## Proposal for amendments regarding WP.29/2022/59

Modifications to the existing text of UN-Regulation No. 157 are in **bold** for new or ~~striketrough~~ for deleted characters.

#### Model A

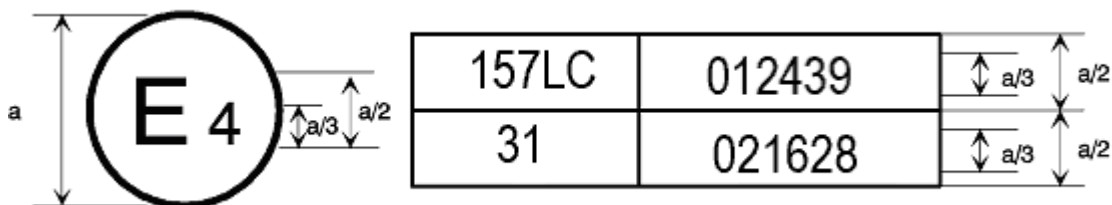
Annex 2, amended to read:

The above approval mark affixed to a vehicle shows that the vehicle type concerned has, with regard to ALKS, been approved in the Netherlands (E 4) pursuant to UN Regulation No. 157 under approval No. ~~002439~~ **012439** and is capable of a lane change procedure. The approval number indicates that the approval was granted in accordance with the requirements of UN Regulation No. 157 ~~in its original version~~ **with the 01 series of amendments incorporated.**
